CALIFORNIA COASTAL COMMISSION

**STAFF REPORT: REGULAR CALENDAR**

APPLICATION NO.: 4-01-037

PROJECT LOCATION: 21343 Hillside Drive, Topanga, Los Angeles County

Figure 1. Project site (The Bob Trust) showing large California live oaks and sensitive drainage to Topanga Canyon. Possible Alternative Sites for the residence, driveway and garage on the 9.44-acre site are shown.

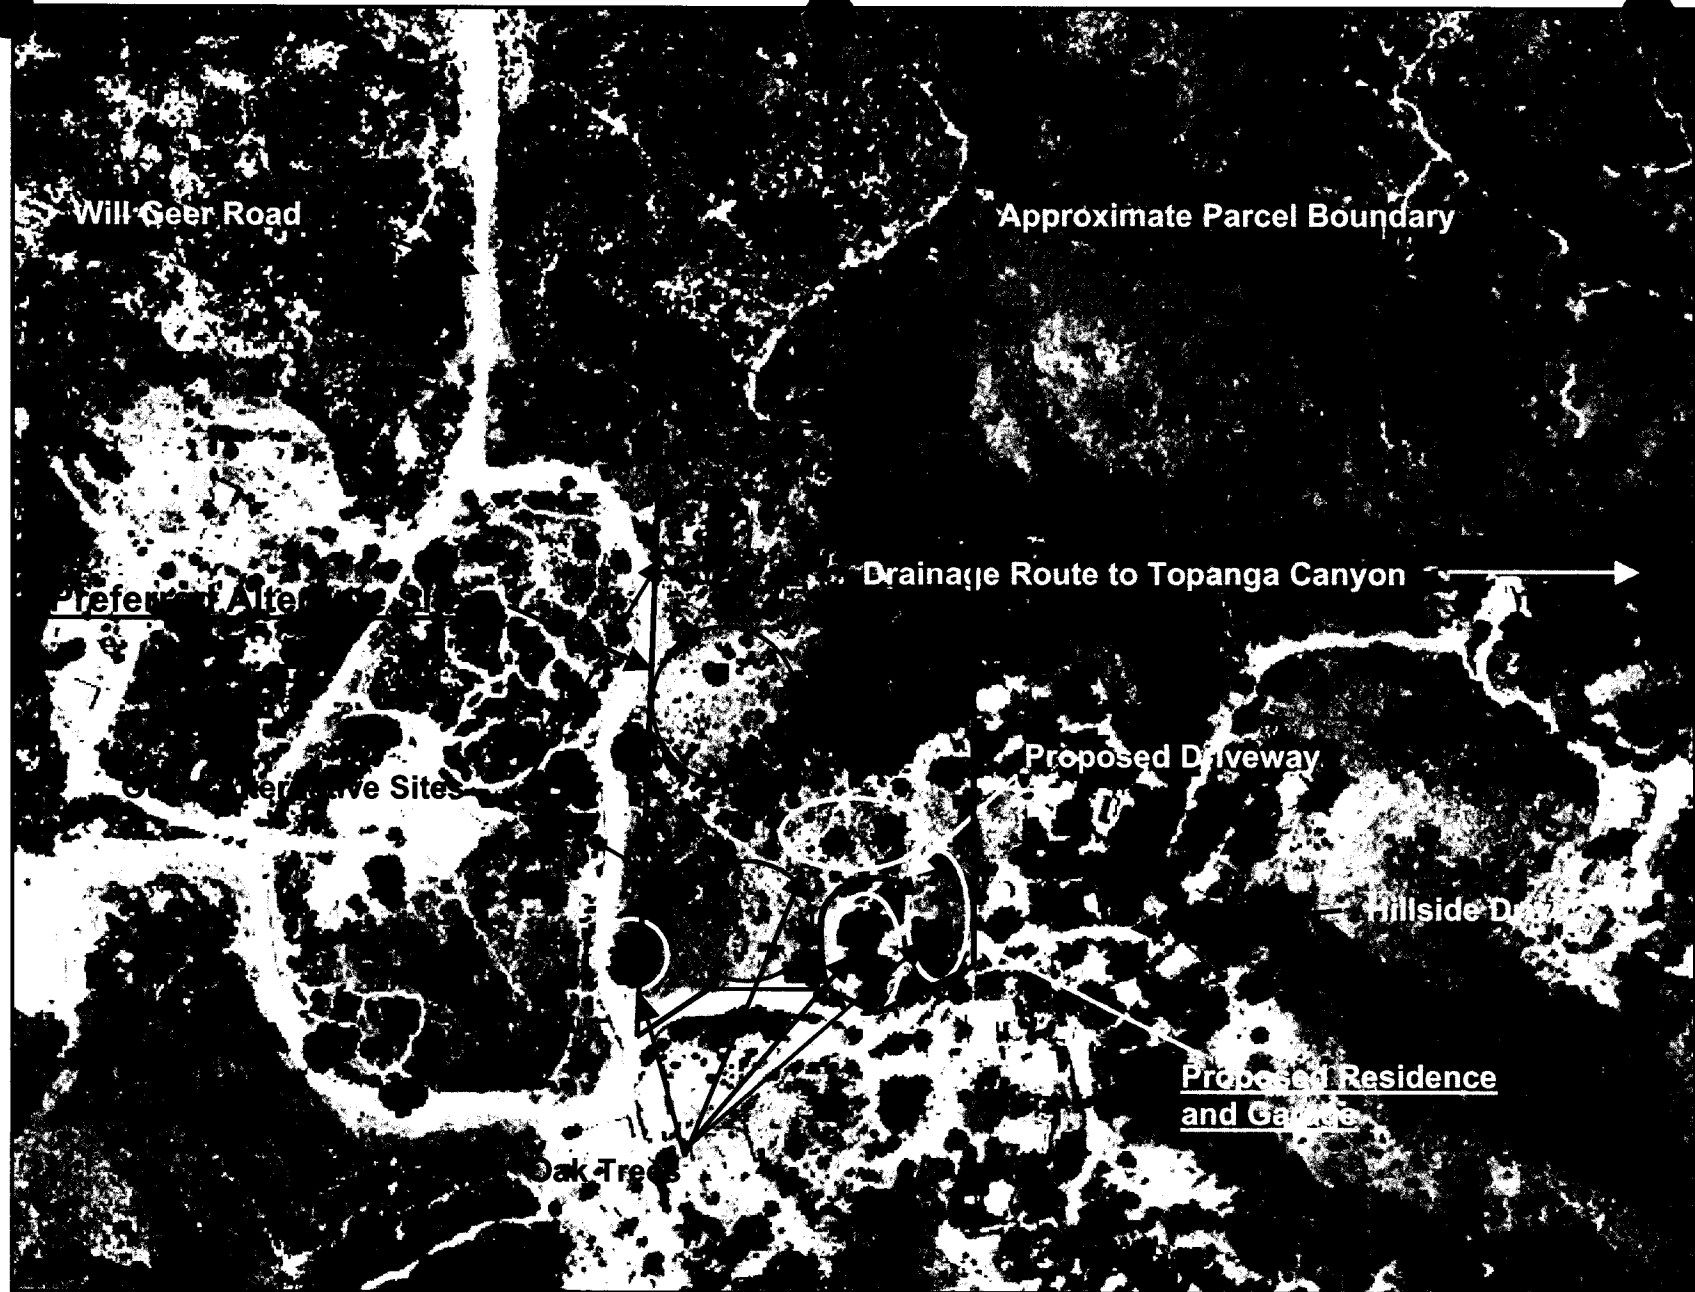
With the residence in the proposed location impacts to the three large oak trees labeled 1, 2 and 3 are inevitable. The combination of increased watering associated with landscaped fuel modification zones and non-native plants in these areas are not the native environment to which oak trees are adapted. The zones "A", "B" and "C" for fuel modification are described in the County of Los Angeles Fire Department (LAFD) Assessment for Fuel Modification Plan #1126 dated April 3, 2001. The zones shown on the Preliminary Fuel Modification Plan map completely surround the three large oaks directly in front of the proposed residence, and have to be adjusted into awkward shapes to avoid the protected zones of the trees. In Zone A irrigation is recommended by LAFD to maintain healthy vegetation with high moisture content. In the next zone, Zone B, irrigation is also recommended to maintain healthy vegetation with high moisture content. Finally in Zone C removal of most native species common to the area such as chamise, red shank, California sagebrush, common buckwheat and sage is recommended. The 200 foot fuel modification radius will require that about three acres or 1/3 of the site will be impacted by fuel modification changes. This increased irrigation near the residence and runoff from the driveway surrounding the trees will add greatly to the moisture content in the root zones of these oaks. Increased moisture around oaks particularly during the summer months that would be dry otherwise may lead to fungal pathogen infection in the root zone by Avocado Root Rot (*Phytophthora cinnamomi*) and Oak Root Fungus (*Armillaria mellea*).

While the irrigation and fuel modification requirements noted are a concern of the proposed project, an even greater concern is the impact to the largest oaks of grading for the driveway and the fire turnaround area. The grading plans call for 500 cubic yards of cut, 500 cubic yards of fill and 2,167 cubic yards of over excavation. Much of this will be for the driveway and fire turnaround that must be strong enough to support large fire trucks. The area to be excavated, refilled and compacted is on the downhill side of the largest oaks, an area that the arborist, Kay Greeley, has noted in the Alternatives Analysis as requiring a 50-foot setback from the oaks. This is because the root zones of these oaks tend to grow downhill toward drainages, and this was in fact cited as one of the arguments against Alternative Site "B" on the downhill side of the large oaks in the alternatives analysis. This is precisely where the driveway will be located for the proposed residence. This suggests that the proposed project as designed is a serious threat to the largest oak trees on the site even according to the Oak Tree Report in the Application.

As an exhibit we present Figure 1 showing the project site and surrounding area along Hillside Drive and Will Geer Road on Topanga Mesa. As indicated above and shown on the Figure the proposed project would be impacting ESHA and would therefore place the residence, driveway, fire turn-around and garage in a position completely surrounding the large oaks on the site. In this location there is a high risk of degradation to the largest oak trees by the proposed grading for the driveway, detached garage and residence and proposed removal of one of the oak trees. It is therefore staff's conclusion that other potential sites as shown on the Figure are a much less damaging and preferred alternative.

As identified on Figure 1 in the Staff Ecologist's Report (Exhibit 20), there is an alternative site located on the southwest portion of the subject parcel where it appears that a residence could be constructed in compliance with Section 30240. A building site located along the slope on either side of the drainage ravine should be considered. Such a site should be located at least 100 feet from the outer edge canopy of any oak tree and may require the removal of some chaparral. A building site in this location may be limited in size resulting in a smaller development area. The site could be accessed from a short direct driveway from Hillside Drive.

As identified on Figure 1 in Exhibit 20 and on Exhibit 22, there is a site that is relatively flat located immediately east of Will Geer Road that appears to be the preferred alternative site. There is limited chaparral on this site; the largest is a manzanita of the size of a small tree rather than a shrub. Limited grading may be required due to the relatively flat topography of this site and the need for only a short direct driveway to access the building site from Will Geer Road from the west. It appears that construction of a residence, garage and driveway at this site would comply with Section 30240.

Exhibit 23. Application 4-01-037. View to the South from small hill overlooking preferred alternate building site adjacent to Will Geer Road at right. Photo taken from alternate building site at NW portion of parcel (see Fig. 1).

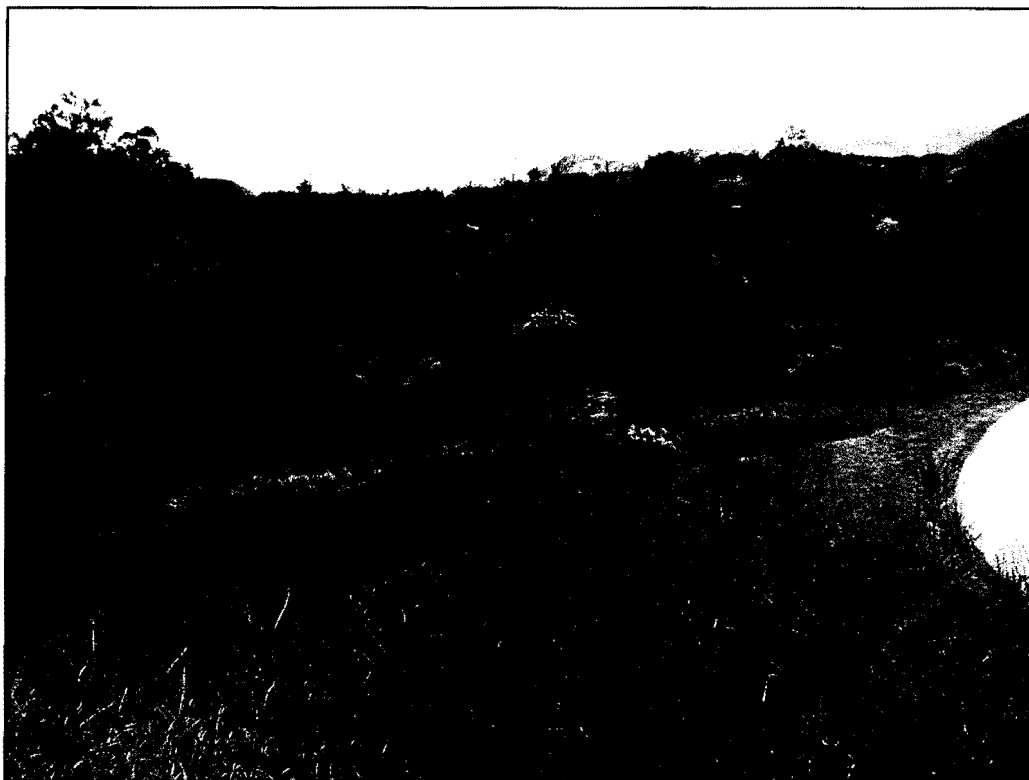
There is a small knob hill at this site where a residence could be located. A garage could be located at the base of the hill to minimize the grading and landform alternation necessary to construct a small to modest size residence. Existing chaparral vegetation would need to be removed to construct a residence and detached garage at this site.
